Product Change Notice (PCN)

PCN Number: **PCN-0450972R-01**

Product(s) Affected: *SJ1-351XN Series. (SJ1-3513N, SJ1-3514N, SJ1-3515N)*

PREVIOUS CUI DEVICES DETAIL / IMAGE			NEW CUI DEVICES DETAIL / IMAGE

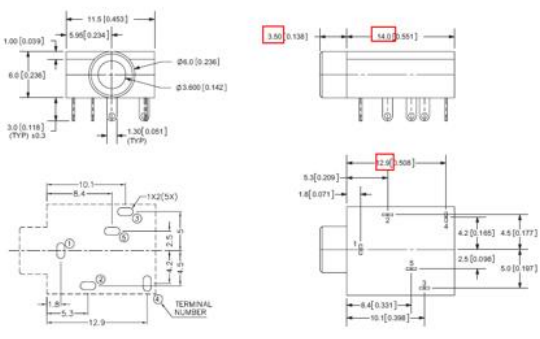
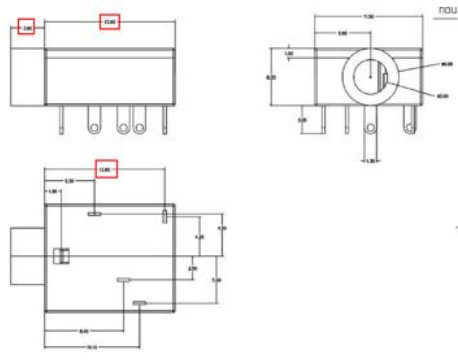
Reason(s) for Change: *Tooling and Material Change*

Description of Change: *Slight Dimensional difference. Terminal Material Change See image Below*

MATERIAL	PLATING	DESCRIPTION	MATERIAL	PLATING/COLOR
terminal 1	brass	silver	terminal 1	brass t=0.3	silver
terminal 2	brass	silver	terminal 2	phosphor bronze t=0.3	silver
terminal 3	brass	silver	terminal 3	brass t=0.3	silver
terminal 4	brass	silver	terminal 4	brass t=0.3	silver
terminal 5	brass	silver	terminal 5	phosphor bronze t=0.3	silver
bushing	brass	nickel	bushing	brass	nickel
spring	stainless steel		spring	steel	black
cover	PBT		cover	PBT (UL94V-0)	black
plastic	PBT		housing	PBT (UL94V-0)	black
